# **Monitoring Report MY05**

**Stony Fork Restoration Site  
Upper Neuse River Basin - 03020201  
Monitoring Year 05  
DMS Contract 6830**

## MEMORANDUM

Date: February 26, 2024  
To: Danielle Mir, DMS Project Manager  
From: Adam Spiller, Project Manager  
KCI Associates of North Carolina, PA  
Subject: MY-05 Monitoring Report Comments  
Stony Fork DMS #6830, Contract 006830  
Neuse River Basin CU 030202018  
Johnston County, North Carolina

**SHEET 3 of 4**  
 Source: Google Earth, 2018

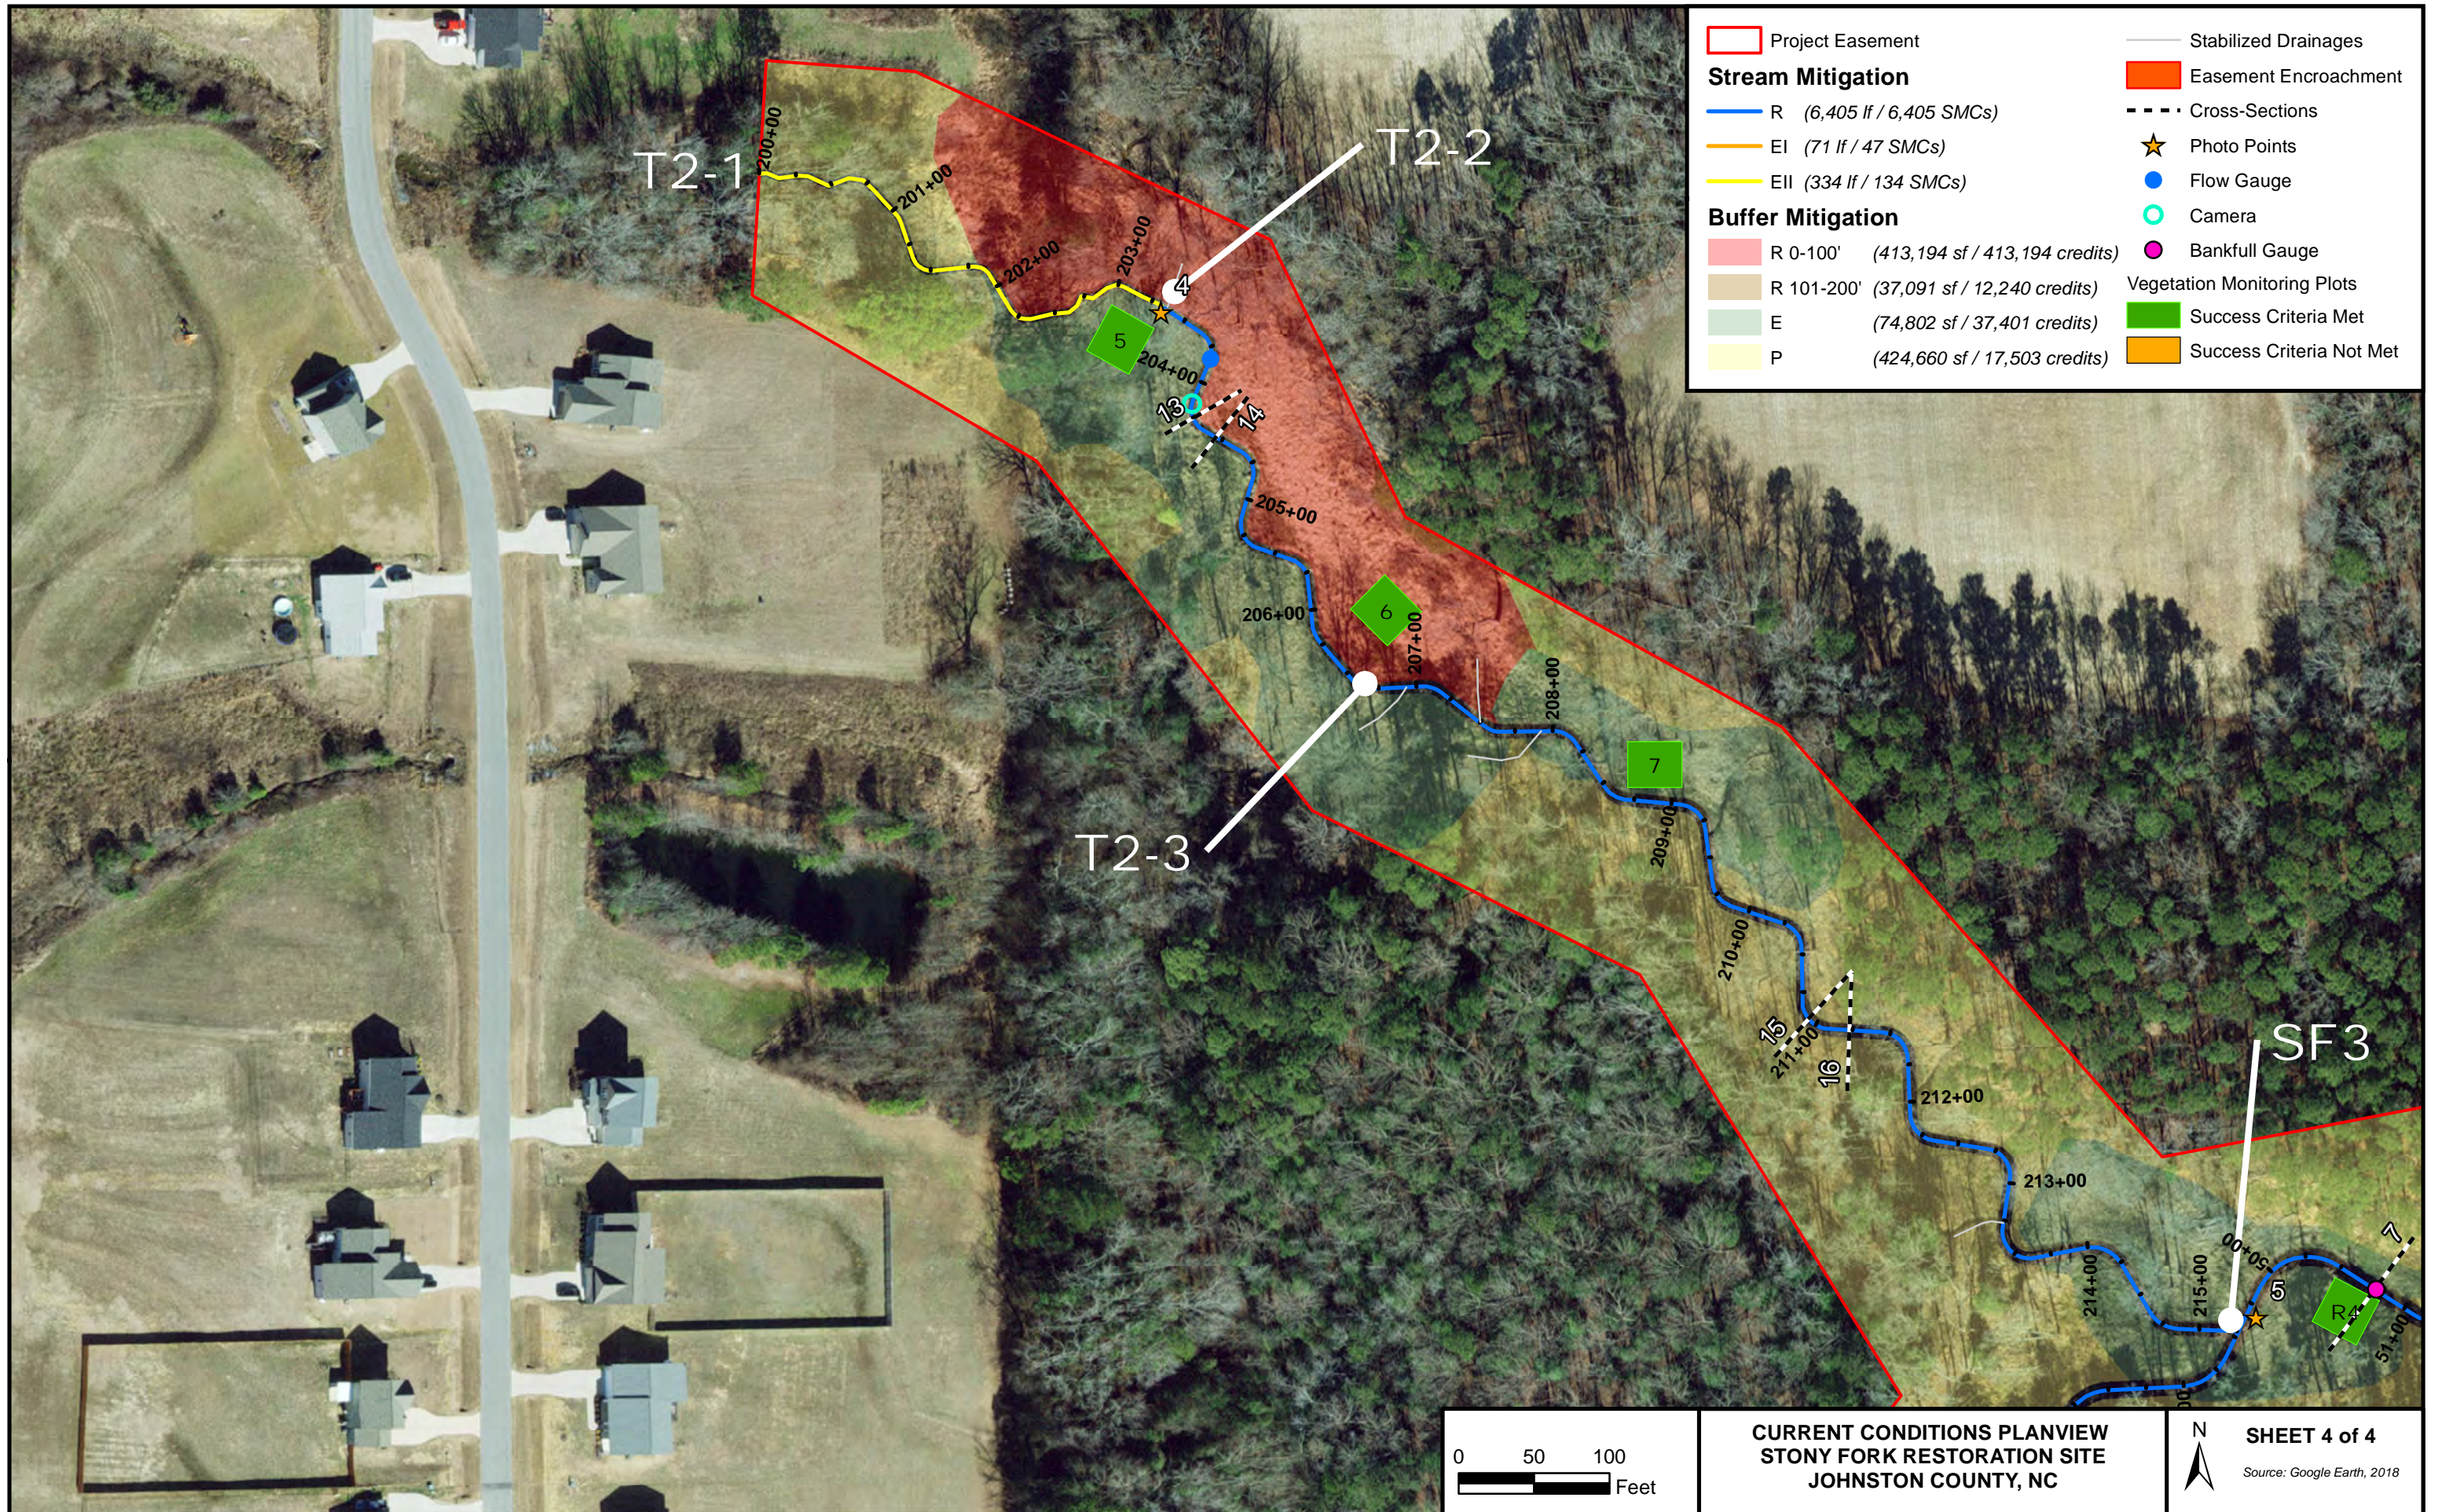
1. Table 1 - Please display credits to 3-decimal places.  
*KCI Response: This error has been corrected.*
2. CCPV – DMS recommends showing the non-credited streams inside the easement with a symbology of a grey /black line labeled “non-credited stream.” Below is a rough sketch of the estimated locations of these streams.  
*KCI Response: At the start of the project, the features in question were determined to not constitute streams. These ephemeral drains were stabilized as part of the project and have been added to the CCPV and labeled “Stabilized Drainages.”*
